Technical Service Bulletin

00 Bolts for the charging station are missing

00 21 53 2063335/2 October 13, 2021. Supersedes Technical Service Bulletin Group 00 number 21-45 dated May 17, 2021 for reasons listed below.

Model(s)	Year	VIN Range	Vehicle-Specific Equipment
Audi e-tron quattro, Audi e-tron sportback	2021 - 2022	All	Not Applicable

Figure 2. The location where the bolts used to be installed.

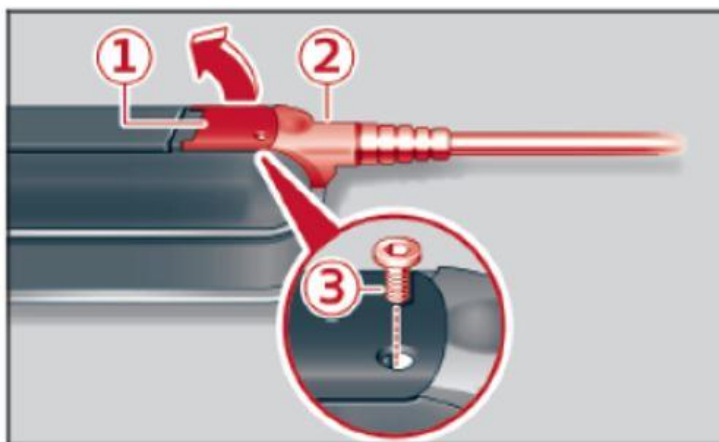
Bolts (part number 9Y0 927 129) for securing the connector in the charging unit have been discontinued (Figures 1 - 2).

As of production date 01/11/2021, the fixing bolts can be ordered via the parts system if the customer desired them but cannot be invoiced under warranty.
